## **DOE Moab UMTRA Responses to Nuclear Regulatory Commission (NRC) Staff Comments on “Crescent Junction Disposal Site Alternative Final Cover System 90 Percent Design Report”**

By letter dated April 6, 2022, the U.S. Department of Energy, Office of Environmental Management (DOE-EM) and Moab Uranium Mill Tailings Remedial Action Project submitted for the U.S. Nuclear Regulatory Commission (NRC) staff's review and comment, a report titled, “Crescent Junction Disposal Site Evapotranspiration Cover System 90 Percent Design Report,” (Design Report) (NRC Agencywide Documents Access and Management System Accession No. ML22096A243). Consistent with the approach used in the review of the 2008 Remedial Action Plan (RAP) (ML080920459), the NRC staff's review process was informed by the “Final Standard Review Plan for Uranium Mill Tailings Radiation Control Act Title I Mill Tailings Remedial Action Plans” (ML110190562), and more recent applicable technical guidance in NUREG-1620, Revision 1, “Standard Review Plan for the Review of a Reclamation Plan for Mill Tailings Sites Under Title II of the Uranium Mill Tailings Radiation Control Act of 1978.”

*Figure 1. Proposed ET Cover with 2ft Surface Admixture Layer*

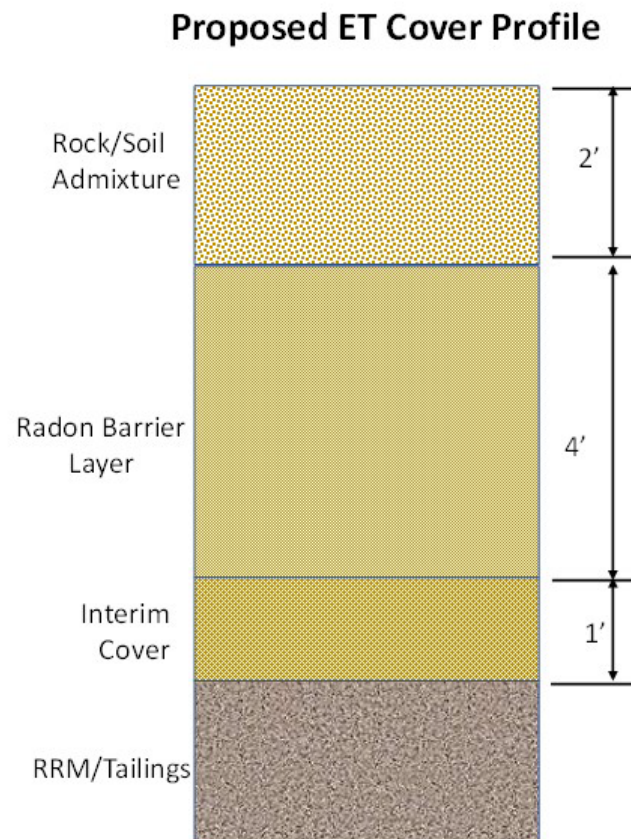
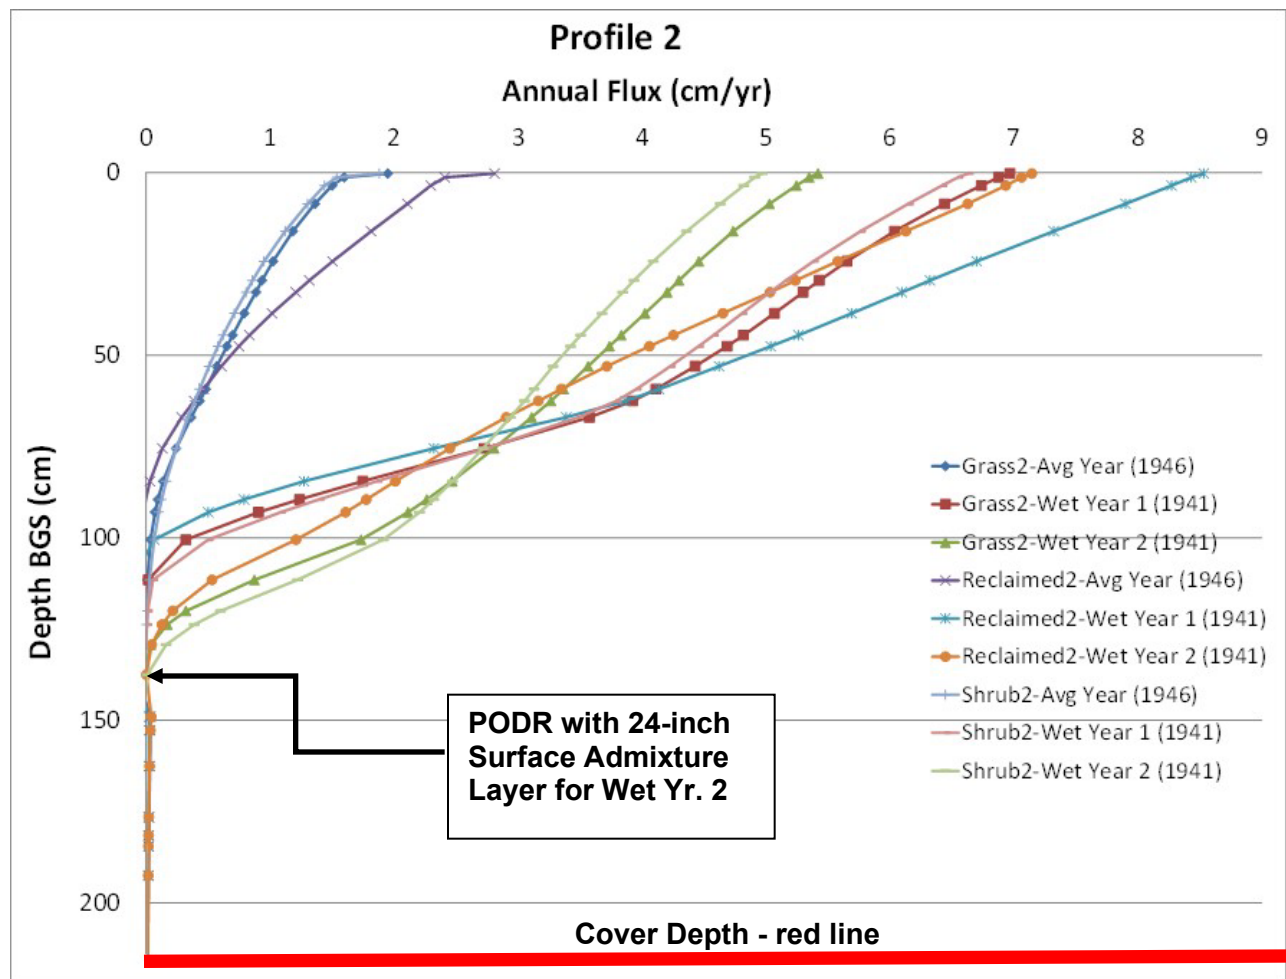
1. In Section 6 and Appendix B of the Design Report, DOE discusses unsaturated modeling of the proposed cover. The Design Report describes the input parameters used in UNSAT-H and provides a summary of the output. The NRC staff appreciates the extent of the modeling that has been done to support the 60 percent design and understands the approach taken to design the proposed cover. ET covers rely on storage of water within the cover and removal of the water by evaporation and transpiration to limit percolation through the bottom of the cover. Conventional covers rely on a low permeability layer to limit percolation through the bottom of the cover.

- a. The design of the cover system is based heavily on the moisture retention properties of the cover soils as well as the properties of the vegetation. The NRC staff's comments on the 60 percent design provided feedback on the relationship between the design calculations and the Technical Specifications. In addition to the particle size requirements that were in the 60 percent design, staff recognizes that DOE has modified the Technical Specifications to include agronomic testing to determine if organic material or other soil additives are needed to support vegetation. This change is helpful. It may be worth further discussion to better aid the NRC staff's understanding of the relationship between the design and the Technical Specifications.

Modeling showed that the point of diminishing returns (PODR) is reached at a depth significantly less than the cover depth and therefore, water balance is not the critical factor to determine the cover depth. The PODR is generally the depth of cover whereby an additional inch of soil depth no longer reduces percolation. In every case, it was the depth that produced an annual zero flux rate. The Design Report, Appendix B included multiple sensitivity analyses that included varied soil input parameters. The cover soil borrow material comes from on-site excavations. There are generally two soil textures - overburden or alluvium and the underlying Mancos shale. Multiple samples of each soil texture were measured. These unsaturated hydraulic property values were each modeled separately to determine the set of values that would require the thickest cover to produce the PODR. The intent of the sensitivity analyses were to make sure that the proposed cover profile effectively minimizes flux due to meteoric water and, in addition, to qualify all on-site cover soil borrow sources. Values from the literature for similar soil textures, as well as values produced from similar soil textures on the Grand Junction project, were included in the sensitivity analysis to determine the worst case set of hydraulic properties (values that required the deepest PODR). The worst-case alluvium properties and the worst-case Mancos shale properties were then combined into a second set of sensitivity analyses in a proposed cover profile. The worst-case vegetation properties were also evaluated.

The combined worst case input parameters (soil and vegetation) are included in the Profile 2 graph that shows the PODR for the beyond worst-case scenario using the wettest year on record while forcing 100% infiltration of all precipitation applied in consecutive years. The output from these sensitivity analyses showed little sensitivity to the soil input parameters. The worst-case soil texture with the worst-case vegetation parameters subjected to the beyond worst-case climate scenario resulted in

a PODR of 140 cm. That is, zero flux is produced with a cover depth of 140 cm (PODR was 89cm to 140 cm depending on the soil textures utilized as input. Refer to the Design Report, Appendix B, Table B-10). Additional sensitivity analyses performed utilizing Grand Junction soil properties suggested in a previous review resulted in a worst case PODR of only 109cm (PODR was 83cm to 109cm). Our cover depth is 213 cm. Consequently, water balance is not driving the depth of cover and further altering soil texture or vegetation properties will have no impact on the cover design. Keep in mind that if one simply compares the proposed cover design results to the existing UMTRA cover profile, the proposed ET Cover reduces recharge to zero while the existing UMTRA cover profile allows recharge at close to the precipitation rate at the site.

*Figure 3. Profile with Thinner 16" Surface Admixture Layer*

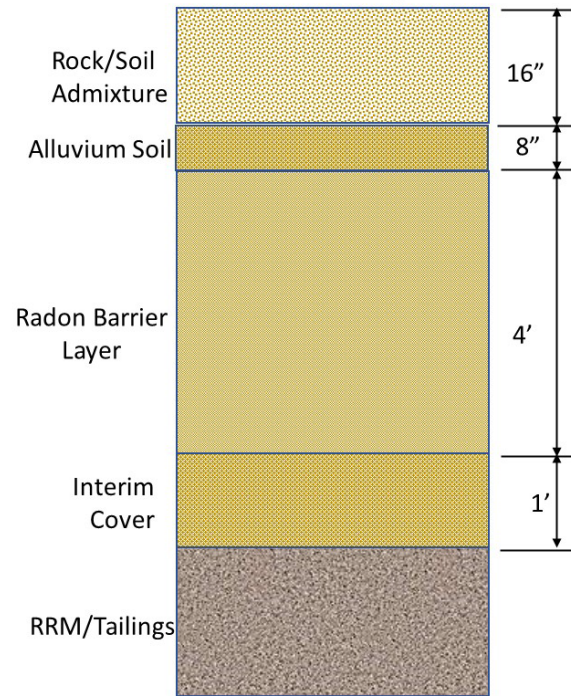
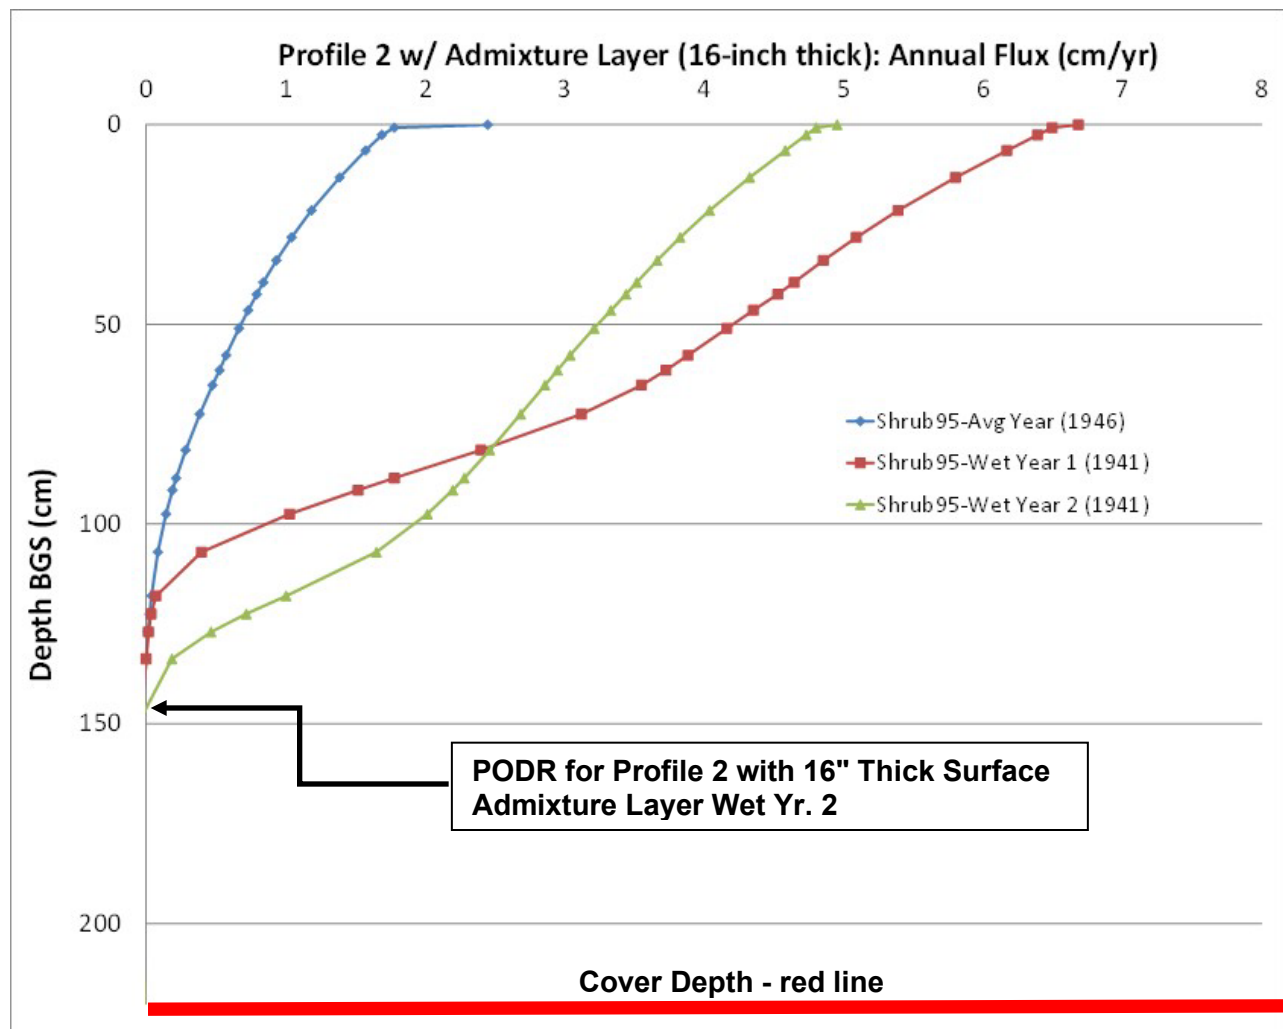
1. The NRC staff reviewed the erosion calculations in Section 3 and Appendix F of the Design Report and appreciates the explanations and modifications that DOE has provided in the 90 percent design. The NRC staff is familiar with the methodology used to design the surface admixture. However, the NRC staff remains concerned about the erosion control aspects of the cover at Crescent Junction, particularly given the relatively thin amount of soil on top of the radon barrier. The staff understands that the

design calls for a gravel/soil admixture at a 30 percent rock to 70 percent soil uniformly mixed through the 24-inch depth. The gravel/soil admixture will overlie the 48-inch-thick shale layer that will serve as the radon barrier. Staff remains concerned in the ability of the gravel/soil admixture to resist erosion without forming gullies or erosion rills. The design calls for the rock component of the admixture to have a D50 of 2.3-inches. Staff has not been able to identify an overall gradation of the gravel/soil matrix; the Design Report and Technical Specifications do not clearly articulate what the final grain size distribution will be for this component of the cover system. Further input on this topic is available in the comments related to soil properties below. Without understanding the final grain size distribution of this layer, staff is concerned that it may be susceptible to erosion and the formation of gullies. This may represent a long-term maintenance issue for DOE-LM. Although not explicitly stated in the guidance document, NUREG-1623, "Design of Erosion Protection for Long-Term Stabilization," was developed around the concept of rock-to-rock contact. With a gravel/soil matrix consisting of 30 percent gravel, the rock-to-rock contact will not be as prevalent as was envisioned in NUREG-1623. As a result, the design may be more susceptible to erosion. Guidance from the U.S. Army Corps of Engineers (USACE) in Engineering Manual 1110-2-1601, Hydraulic Design of Flood Control Channels (USACE, 1994) suggests that well graded riprap be used and identifies target values for the D85 to D15 ratio. Options to consider with the design to make it more resistant to erosion include: increasing the rock size in the gravel/soil matrix; concentrating the gravel in the upper portion of the admixture and filling in the voids with smaller diameter particles (similar to what was done at the Monticello, UT site); or utilizing a shallower slope on the top deck of the disposal cell. Staff recognizes the need to consider erosion resistance, the ability to support vegetation, and the ability to limit percolation can be counter to each other. Further discussion may be warranted to arrive at a design that satisfies each of those goals.

*Based on the NRC comment, an alternative thinner (16") surface admixture was analyzed having 8" thick layer of rock mixed with an 8" thick layer of soil:*

Evaluation of the surface rock/soil admixture was evaluated based on this comment to increase the ratio of rock to soil to 50% each by volume. That is, an 8-inch layer of rock (D50 2.3") would be evenly mixed with an 8-inch layer of alluvium cover soil to produce a 16-inch-thick surface rock/soil admixture layer. This revised layer satisfies the erosion performance objectives. It was also modeled altering the upper 2-ft to include the thinner surface rock admixture with the altered hydraulic properties based on the increased rock content overlying a thin alluvium soil layer on the 4-ft radon barrier. No significant change to water balance results. The modeled cover is still 7-ft thick. The PODR is a little deeper in the profile but still produces a net zero flux within the cover profile. Furthermore, the altered profile was modeled without vegetation and the PODR is satisfied within the cover profile. A graphical summary of these modeling results is shown below the ET Cover Vegetation Comment #2 response which summarizes results without vegetation. Thus, the water balance performance objectives are also satisfied with the thinner admixture layer and a higher rock content.

Abt and Johnson (1991) recommends a minimum rock layer thickness 2 times the D50. The riprap design for the side slopes utilized this while the prior analysis of the surface rock and drainage trenches with slopes less than 10%, a thickness of 3 times D50, was used. In the case of the surface rock/soil admixture; an armorment thickness of rock is actually greater than 3 times the D50. The D50 is 2.3-inches while the depth of rock is 8-inches resulting in an armorment thickness ratio of 3.5. Details of the modeling results from the profile with the thinner surface admixture layer will be made available upon request.

Figure 5. PODR for Profile with 2ft Thick Surface Admixture Layer

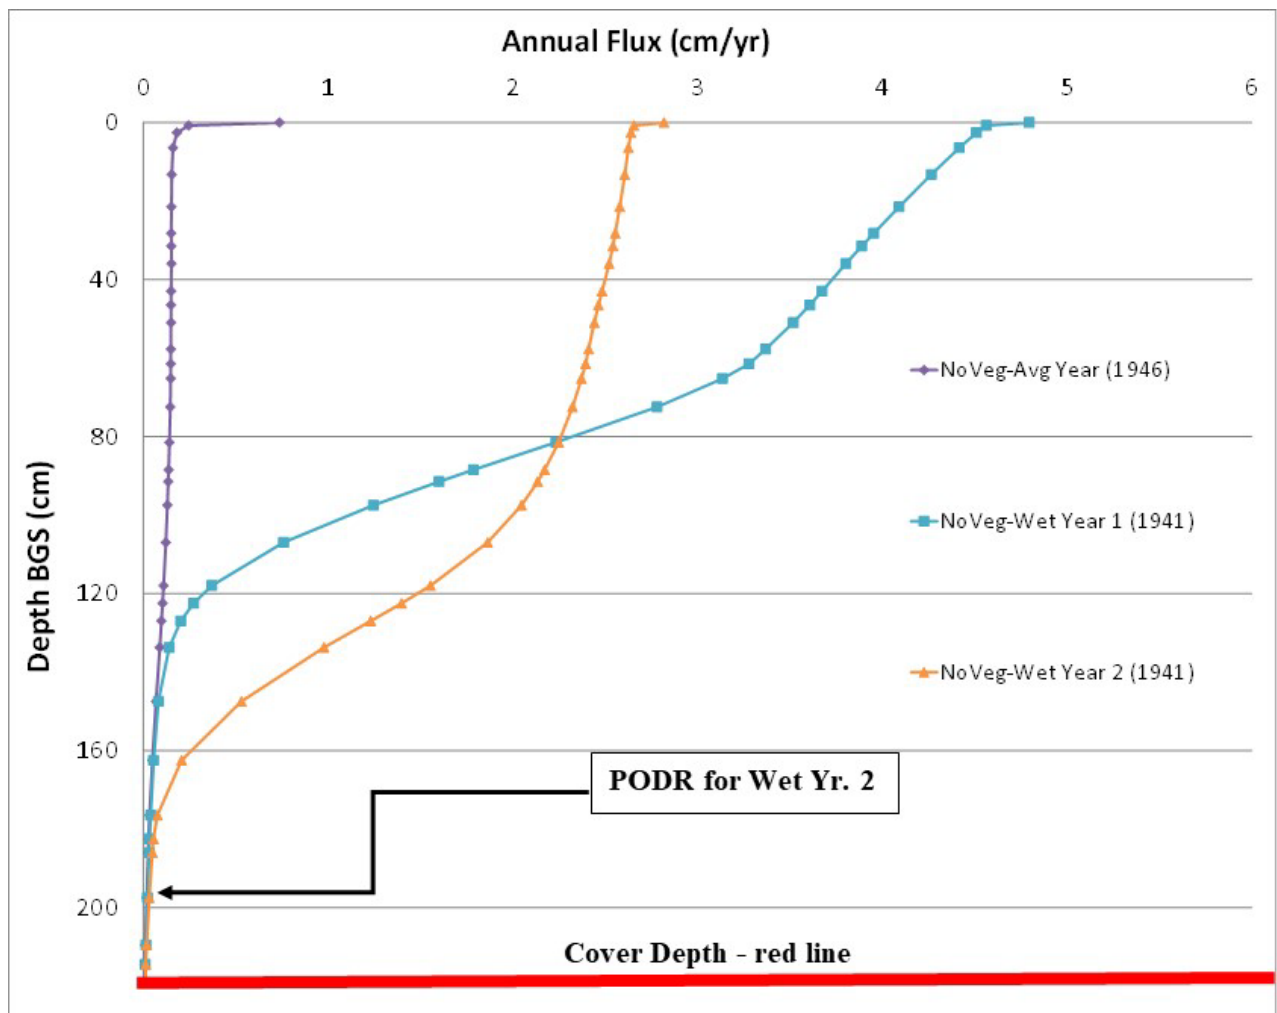
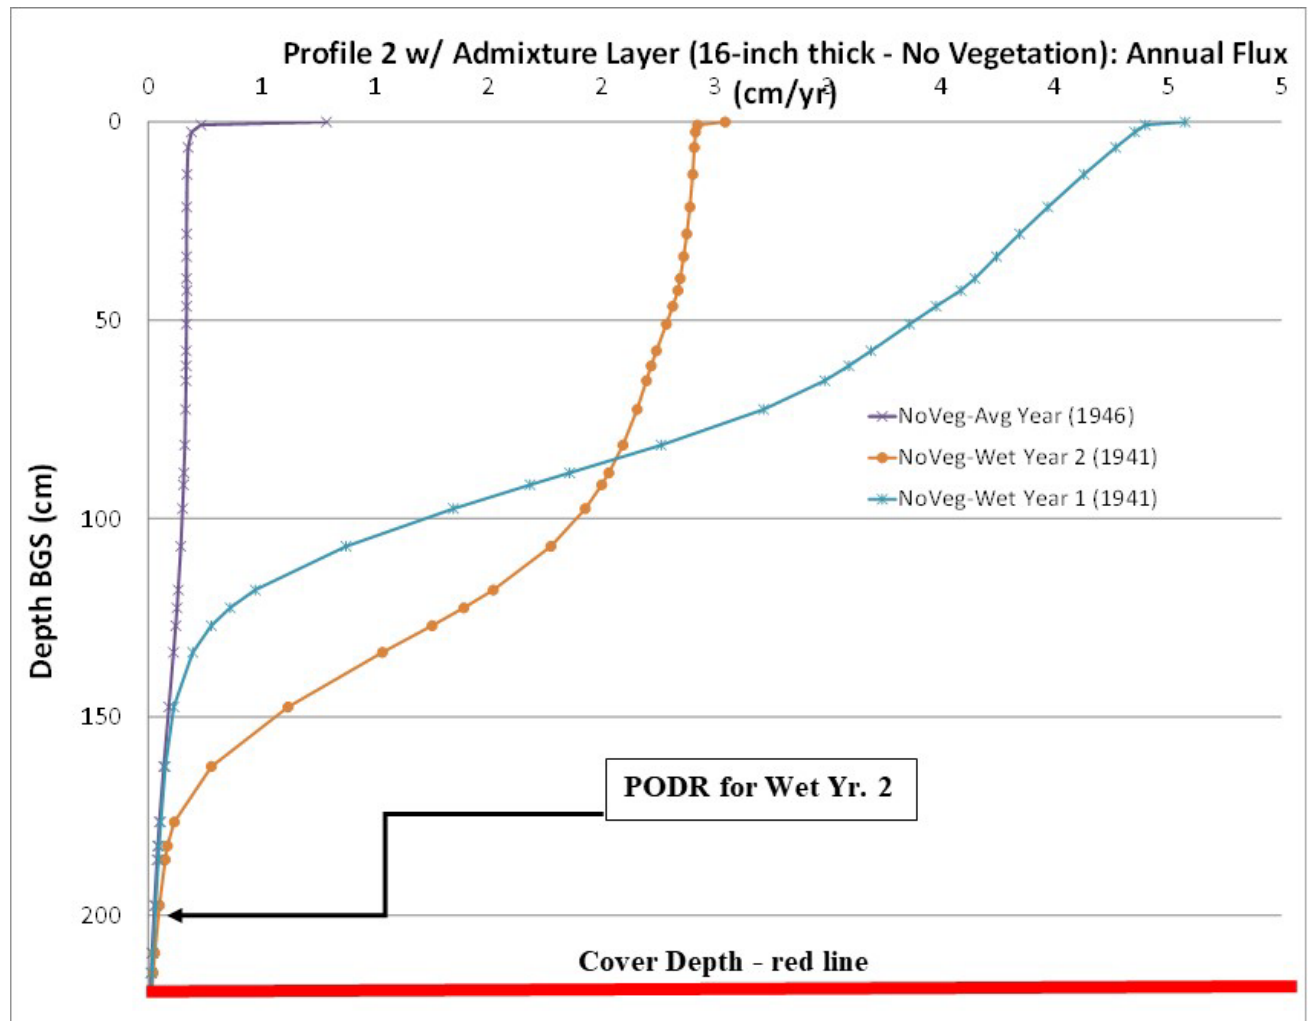
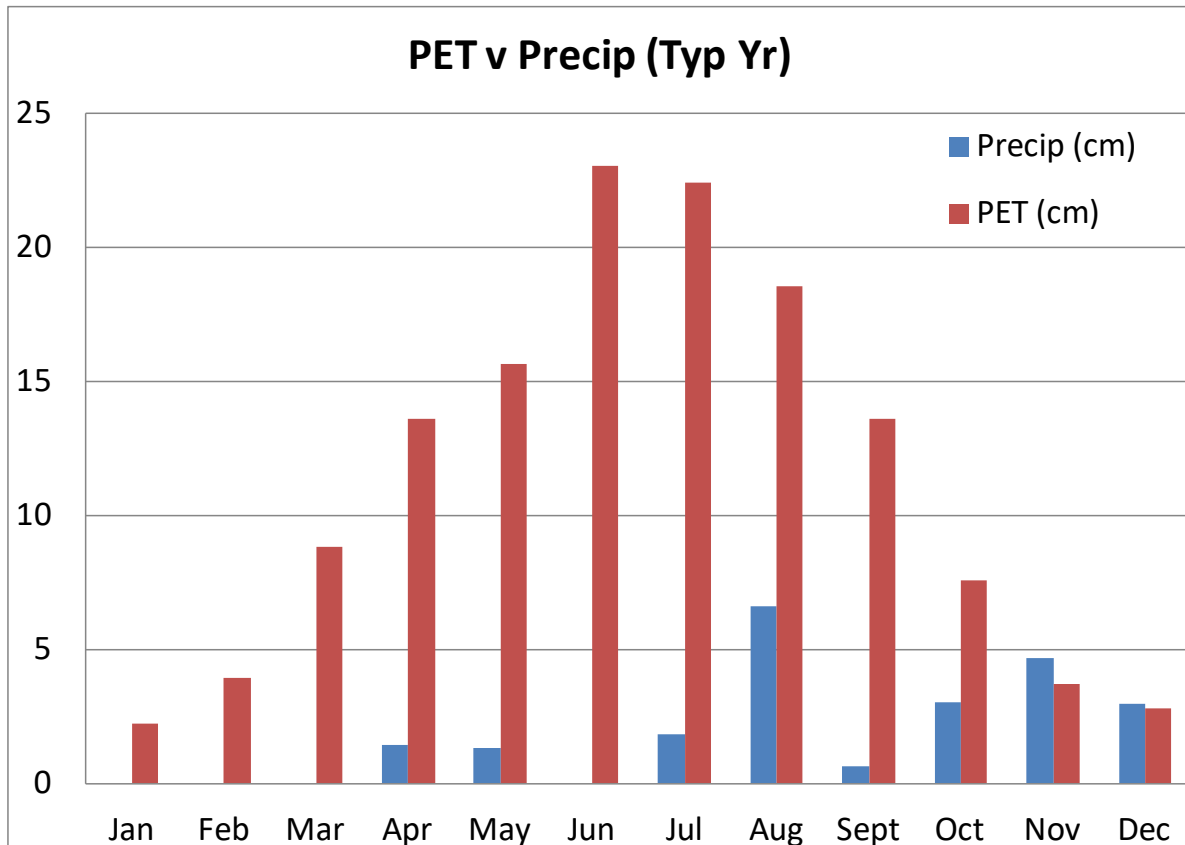
2. Provide the following information related to the establishment of cover vegetation:
  - a. The revegetation success criteria as well as the ecological basis for the selection of the revegetation criteria.
  - b. The time frames for the revegetation target values.
  - c. Details regarding how the proposed revegetation success criteria will compare to the reference area of analog site.

Vegetation is not critical to the design of the cover for either erosion or water balance. Thus, no success criteria have been established. Refer to the graph showing that the annual flux rate estimated for the ET Cover profile without any vegetation is zero (Figure 5). Also refer to the comparison of the PET (demand for water) for the site compared to the precipitation (supply of water) whereby the demand for water is about 6 times greater than the actual supply of water (Figure 6). Thus, a well-designed ET Cover without ponding should produce no percolation with or without vegetation. A graph summarizing modeling results for the modified cover profile with a thinner (16inch) surface admixture is also showed here for information - results show that the PODR is also satisfied within the cover profile depth (Figure 7).
